# Montgomery County Historic Preservation

## Staff Report

<p><b>ADDRESS:</b> 102 E Lenox Street, Chevy Chase</p> <p><b>RESOURCE:</b> Chevy Chase Village Historic District</p> <p><b>APPLICANT:</b> William and Susan Kirby</p> <p><b>REVIEW:</b> HAWP</p> <p><b>CASE NO.:</b> 1159309</p> <p><b>PROPOSAL:</b> Window replacement</p>	<p><b>MEETING DATE:</b> 6/10/2026</p> <p><b>REPORT DATE:</b> 6/3/2026</p> <p><b>PUBLIC NOTICE:</b> 5/27/2026</p> <p><b>TAX CREDIT ELIGIBLE:</b> No</p> <p><b>STAFF:</b> Laura DiPasquale</p>
---	--

Figure 3: Annotated photograph showing the locations of the windows to be replaced.

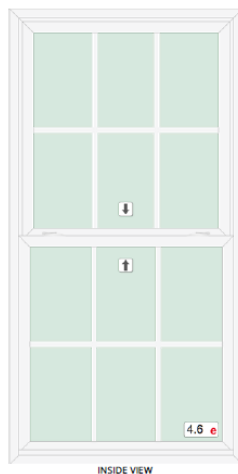
The applicants propose to replace six existing vinyl windows on the front elevation and one existing vinyl window on the east (left) side elevation with new ProVia Aspect vinyl windows with internal grids. The applicants also propose to install new wood trim to the perimeter of the seven windows.

Staff finds that, in addition to material concerns, the design of the proposed windows is incompatible for use on a historic building. Staff finds that the proposed ProVia Aspect vinyl windows do not replicate the profiles, dimensions, or finish of traditional wood windows. Staff finds that the proposed windows have internal grids that create an excessively flat appearance, lack a traditional putty slope relationship between the glazing and sash, have an overly narrow and sash proportions, and include multiple steps in the exterior sash that are not found in traditional wood sash. Staff notes that the HPC has approved aluminum-clad windows with simulated-divided-lights on Contributing resources in the Chevy Chase Village Historic District where the applicants have demonstrated that the proposed windows replicate the

Staff finds that replacing the existing incompatible, non-historic windows with new, equally incompatible windows runs counter to the *Guidelines, Standards*, and Chapter 24A-8(b)(2).

Staff notes that the description of work in the application also includes replacing the existing aluminum window trim with wood, but does not include details on the dimensions or installation of the proposed wood trim.

Staff recommends the HPC deny the HAWP application.
